Grid Code Review Panel – Issue Assessment Proforma Safety Management of 3 Position Gas Insulated Switchgear Isolators and Earth Switches PP 11/58

A Panel Paper by Owen Lloyd (National Grid)

Example diagram identifying the application of OC8A changes.

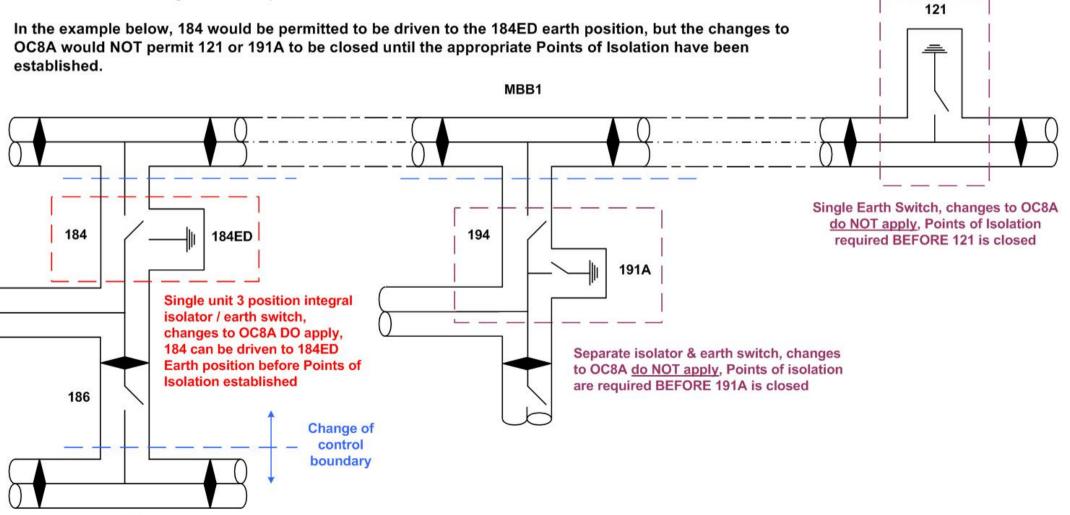
184 & 184ED forms part of a combined & integral single unit which is capable of providing a Point of Isolation & a Primary Earth / Circuit Main Earth such that the Isolator can be driven to the Earth position in a single action by a single operating mechanism.

Where a control boundary exists between 2 users, it is proposed that an addition to OC8A will permit this device to be Earthed before Points of Isolation are established, provided that all Isolators are open & all Safety Co-ordinators are in agreement as per OC8A.5.1

OC8A.5.3.4.
 Some items of HV Apparatus are specifically designed to provide a combined Isolation and Earthing function using a single mechanism contained within a single integral unit. Where Safety Precautions are required across control boundaries and subject to the requirements of OC8A.5.1., it is permissible to Earth before Points of Isolation have been established.
